SPLIT FEED ROLLER SWIPES

**New swipe design for the
50F & 75AD Extruder
allows replacement
without removing
the feed
roller
shaft.**

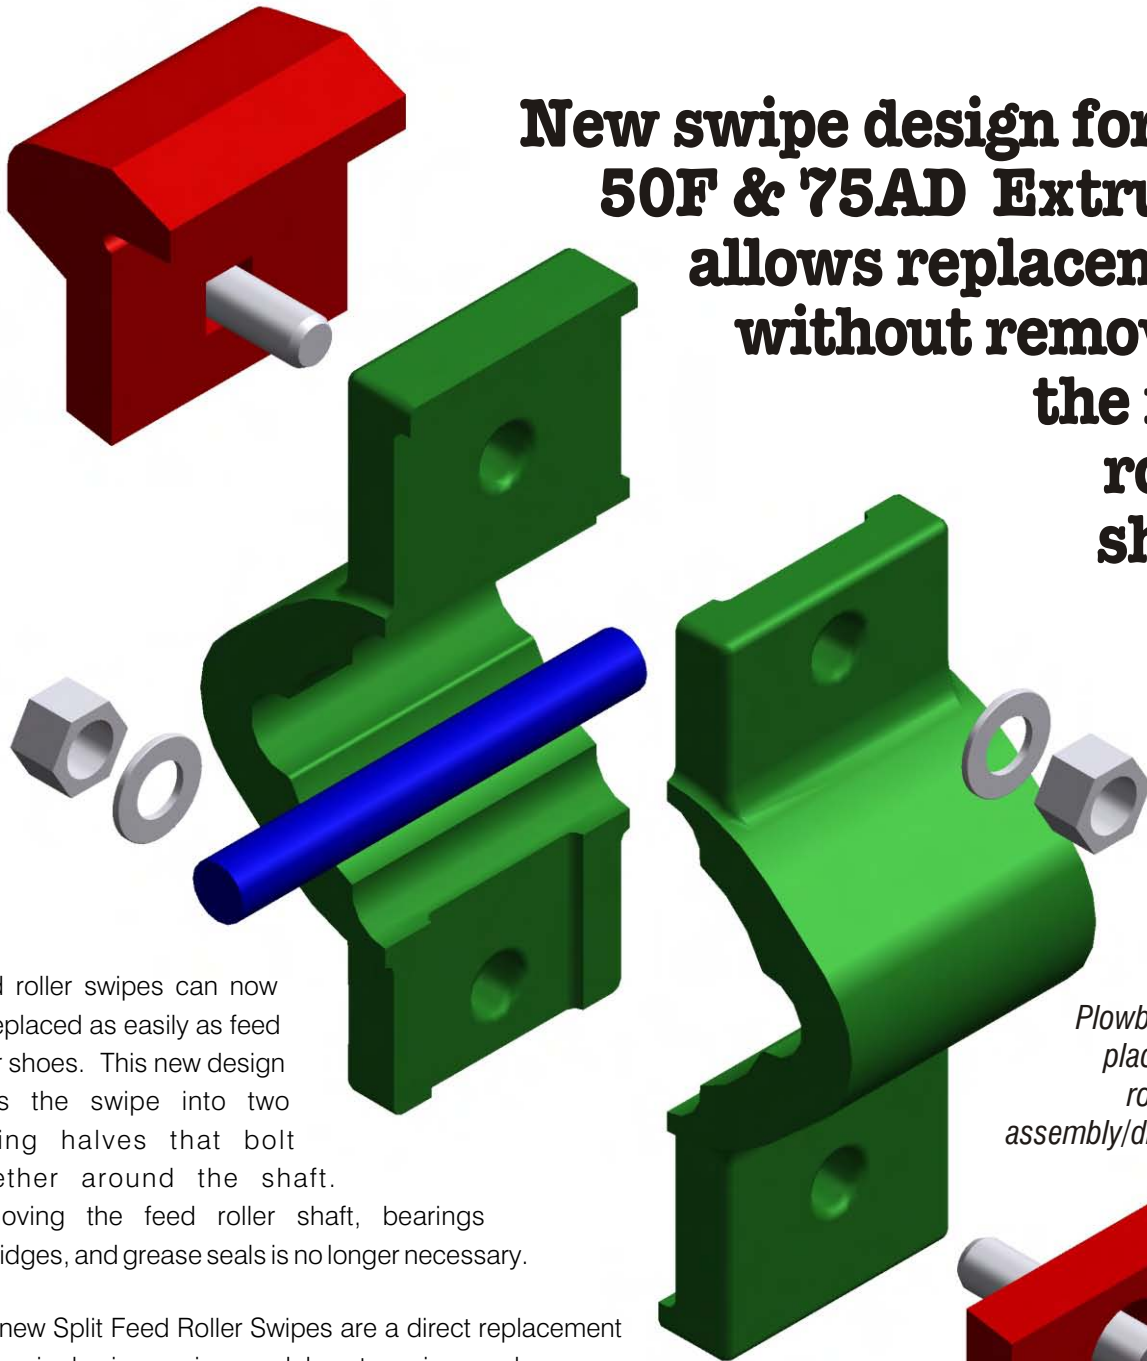
Feed roller swipes can now be replaced as easily as feed roller shoes. This new design splits the swipe into two mating halves that bolt together around the shaft. Removing the feed roller shaft, bearings cartridges, and grease seals is no longer necessary.

The new Split Feed Roller Swipes are a direct replacement for the single piece swipes and do not require any changes to the feed roller shaft.

Plowbolts lock in place - will not rotate during assembly/disassembly
